Army and Navy Sustainable Transport Package – Partner Briefings

March 2022

Design changes

Van Diemans Road Revised Layout

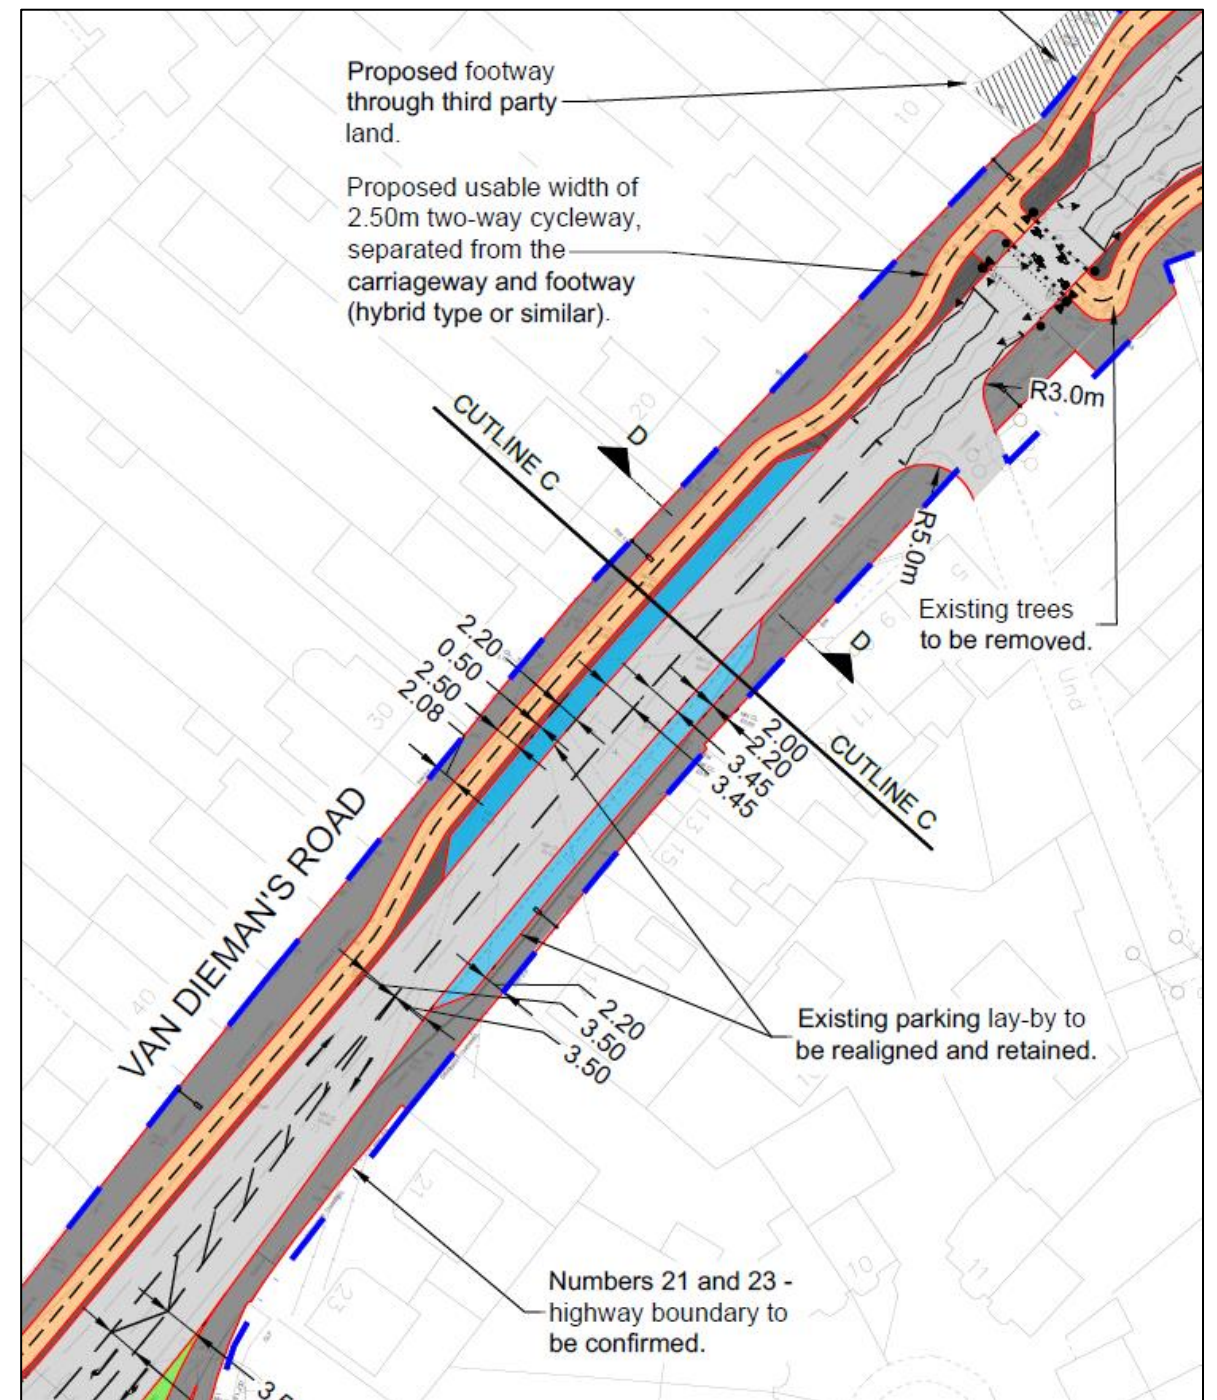
- Concerns about the potential removal of parking bays in Van Diemens Road were raised in a number of responses to the public consultation survey
- Specific comments were made about access for residents and visitors, the absence of alternative parking options, safety concerns and other impacts for residents
- Additional email correspondence was received from residents
- During a site visit with residents it was proposed that we considered one lane of traffic northbound, with reallocation of road space for a cycle lane. Potential improvements to the Lady Lane junction were also suggested

Following the feedback received, we are now proposing a revised layout for Van Diemans Road.

- One northbound lane for general traffic on Van Diemans Road (flaring to two at the Army and Navy junction)
- Capacity improvements at A&N junction result in reduced journey times on VDR compared with existing layout
- Two-way cycle track on western side of Van Diemans Road
- Parking bays on Van Diemans Road realigned but retained
- Crossing close to Army and Navy junction put back to its current position

Lady Lane Junction Option 1:

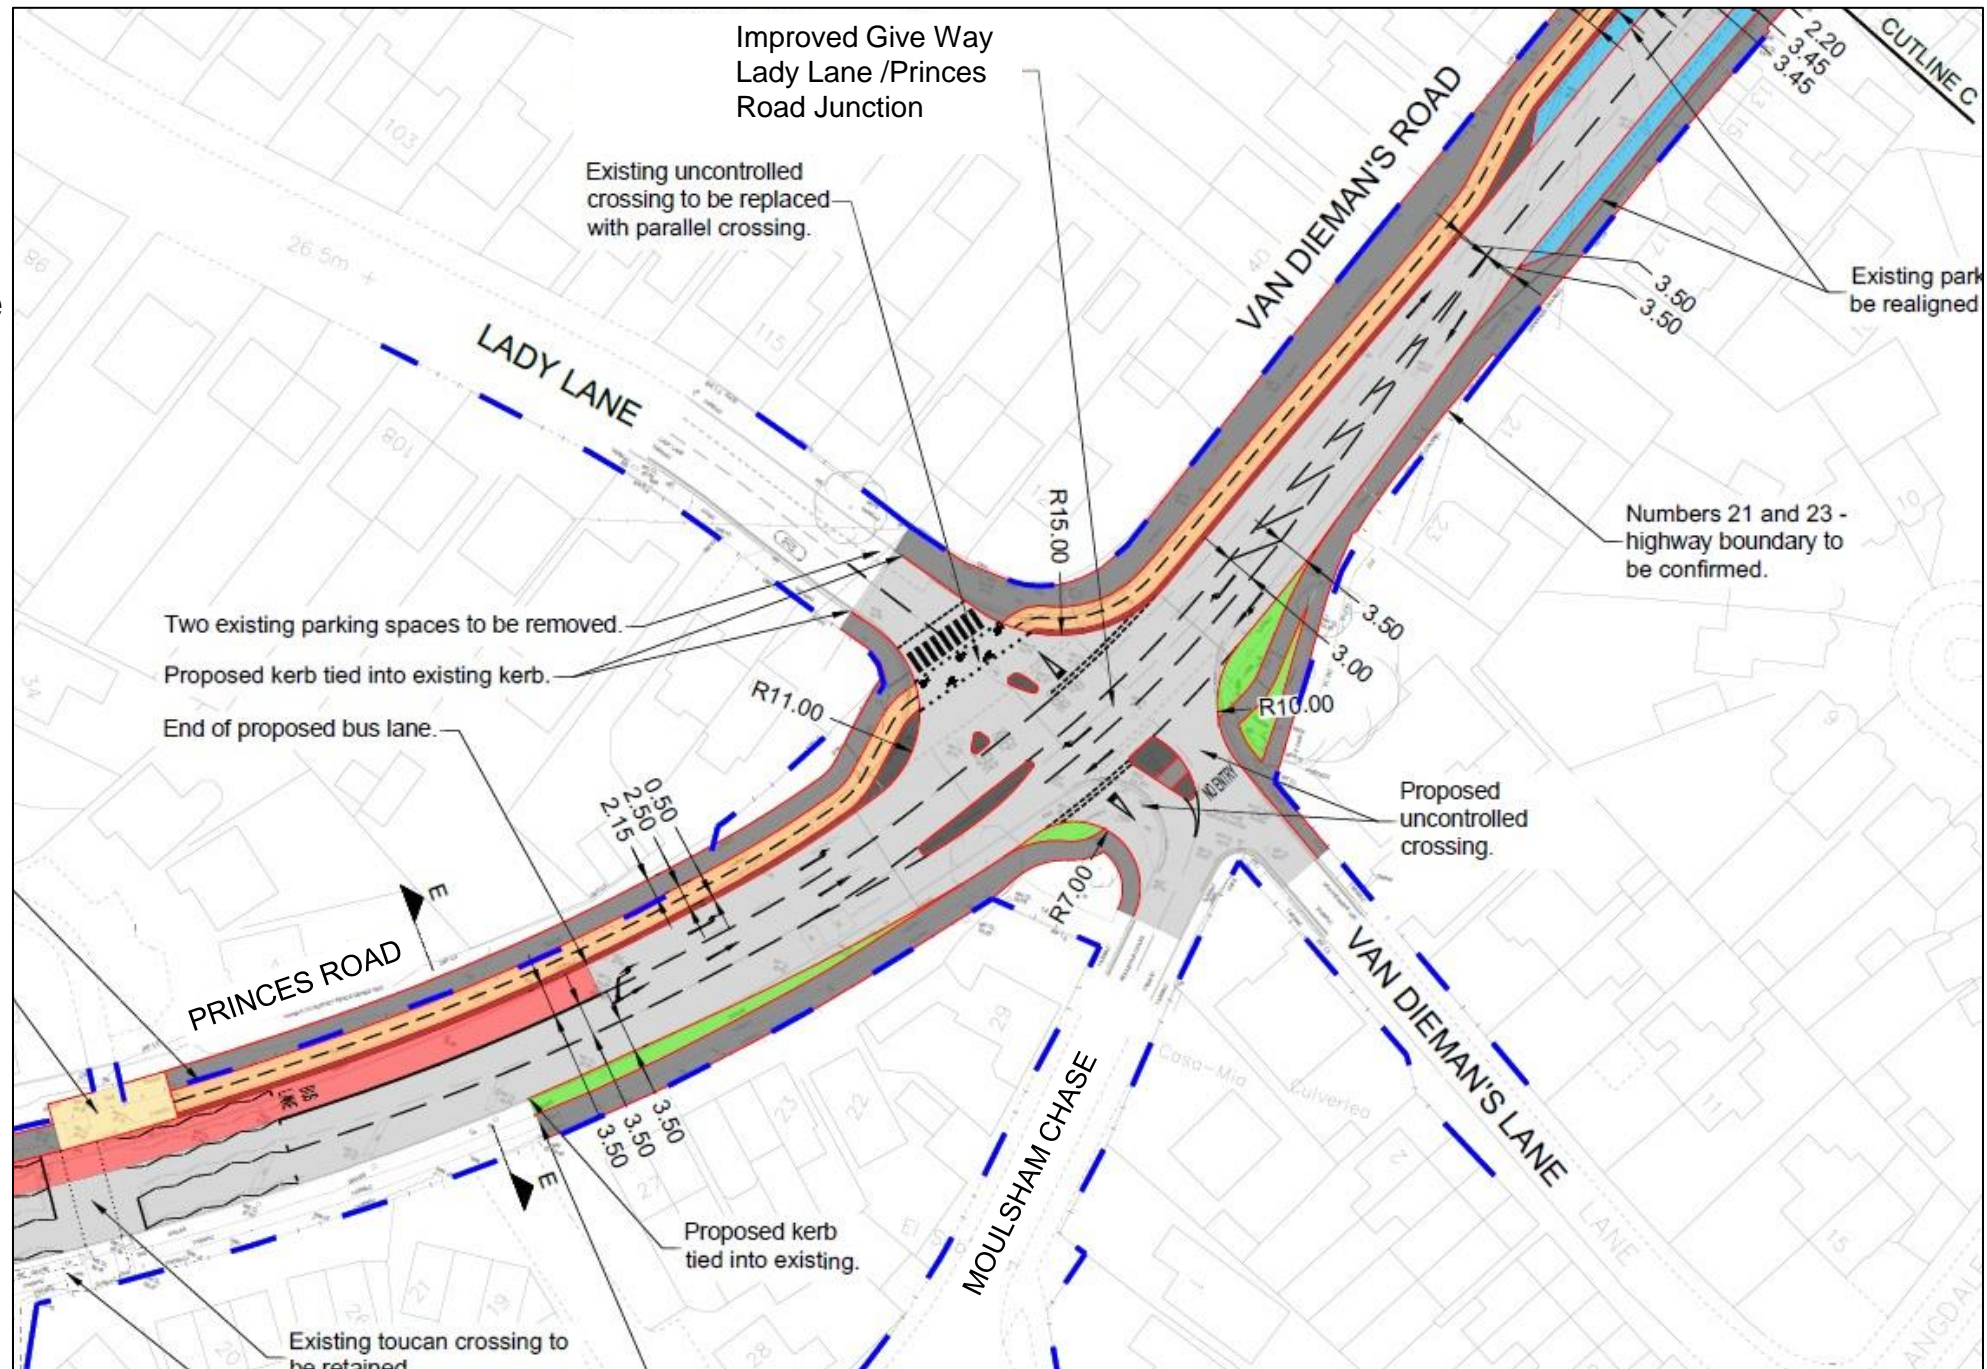
One northbound lane for general traffic on Van Diemans Road and a give way Lady Lane junction.

Traffic movements from Moulsham Chase/Van Diemans Lane would be unrestricted.

Lady Lane Junction Option 2:

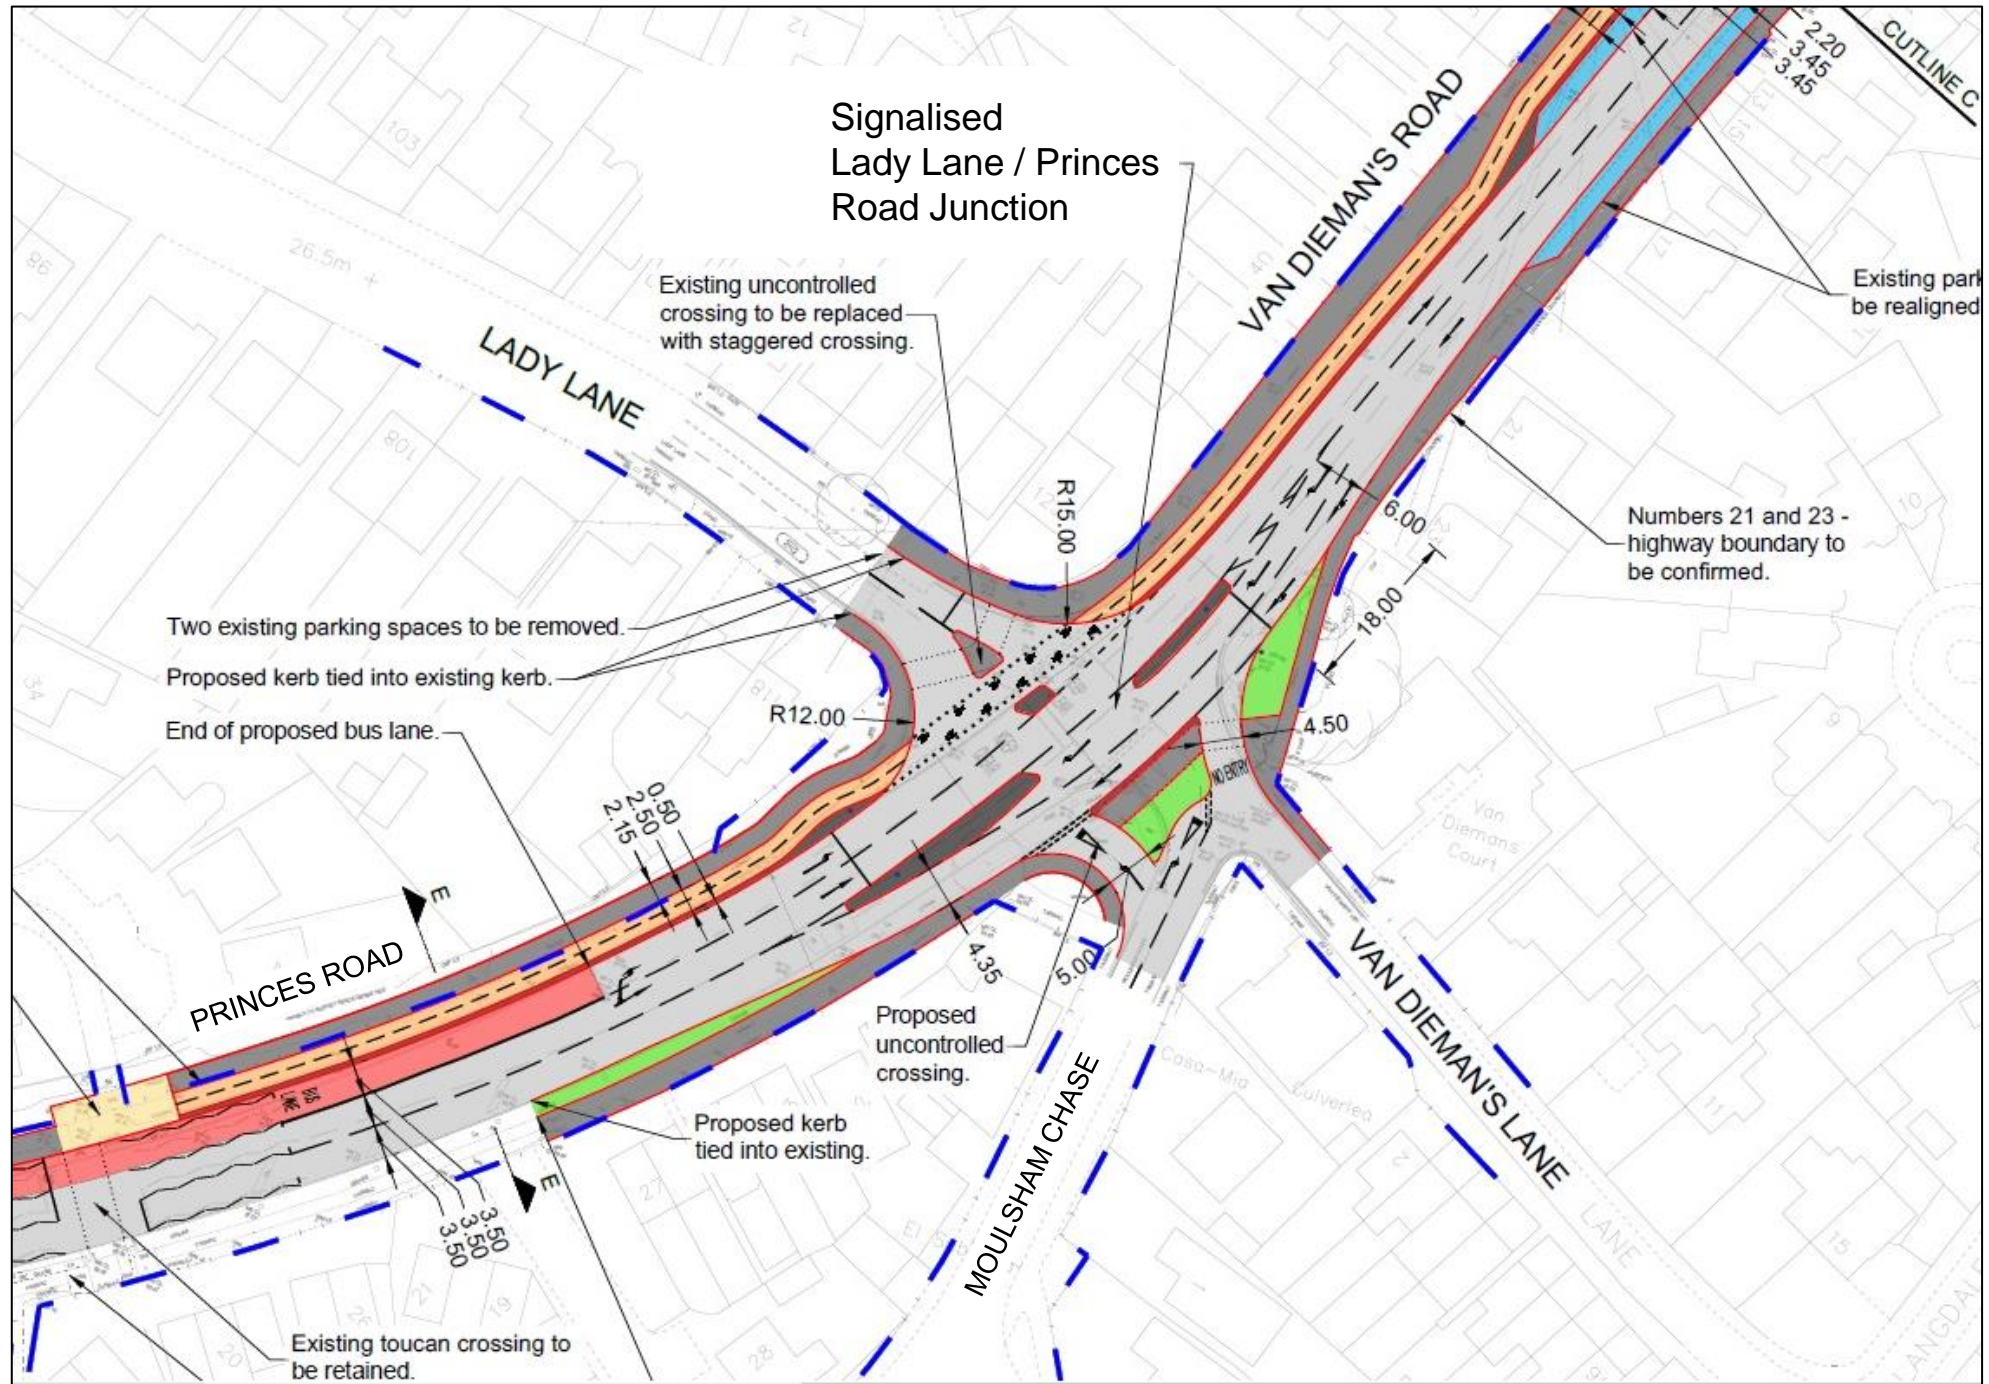
One northbound lane for general traffic on Van Diemans Road and a signalised Lady Lane junction.

Traffic from Moulsham Chase/ Van Diemans Lane would be restricted to left-in and left-out movements.

Lady Lane Junction Option 3:

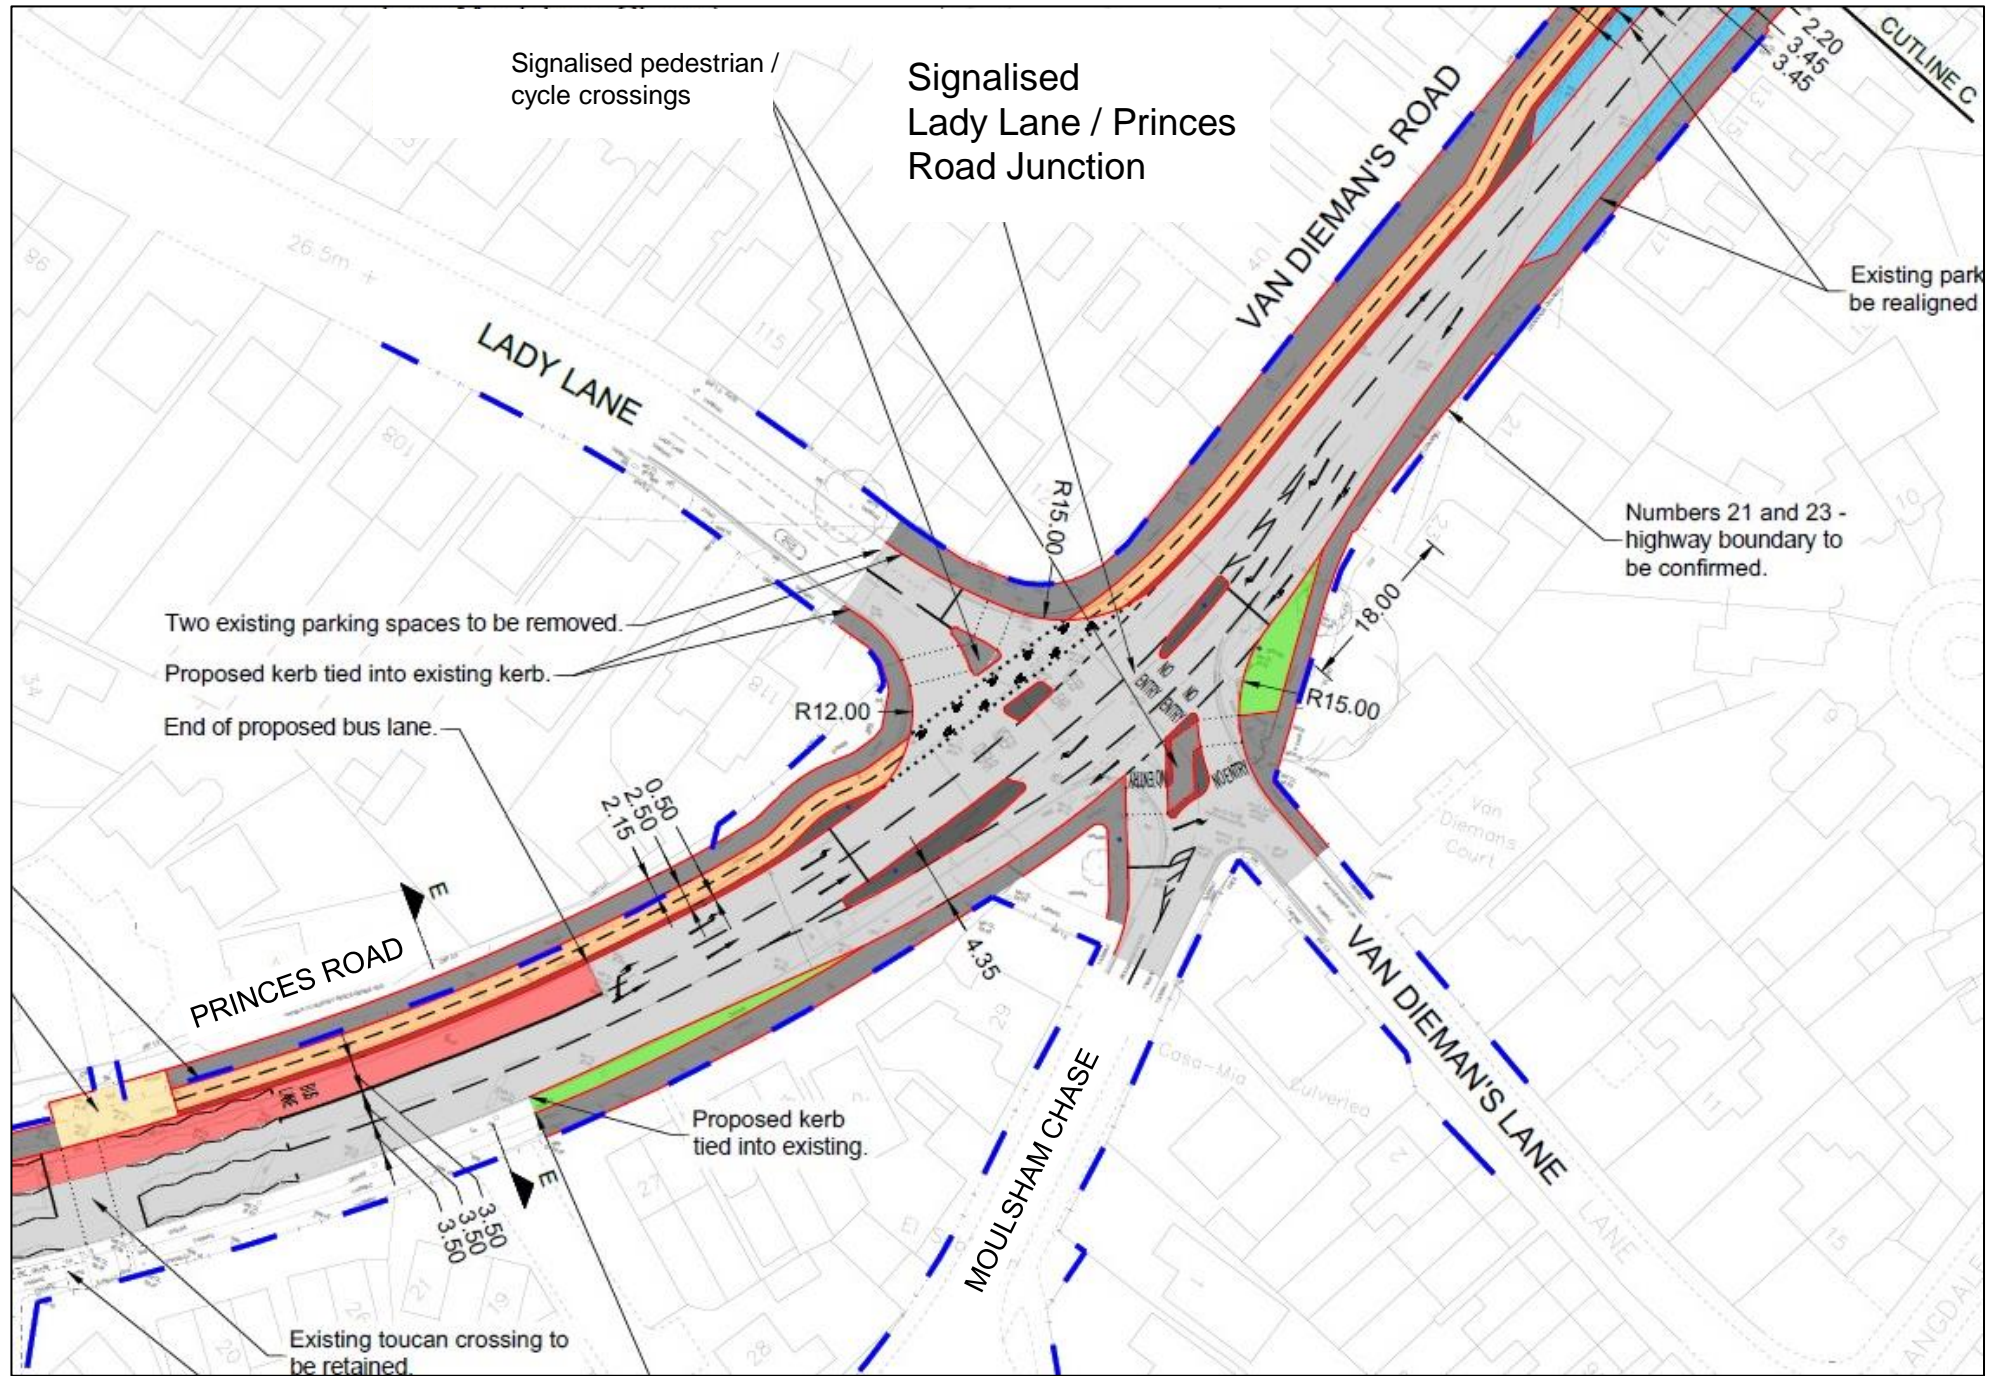
One northbound lane for general traffic on Van Diemans Road and a signalised Lady Lane junction.

Traffic from Moulsham Chase/ Van Diemans Lane would be restricted to left-in and right-out movements.
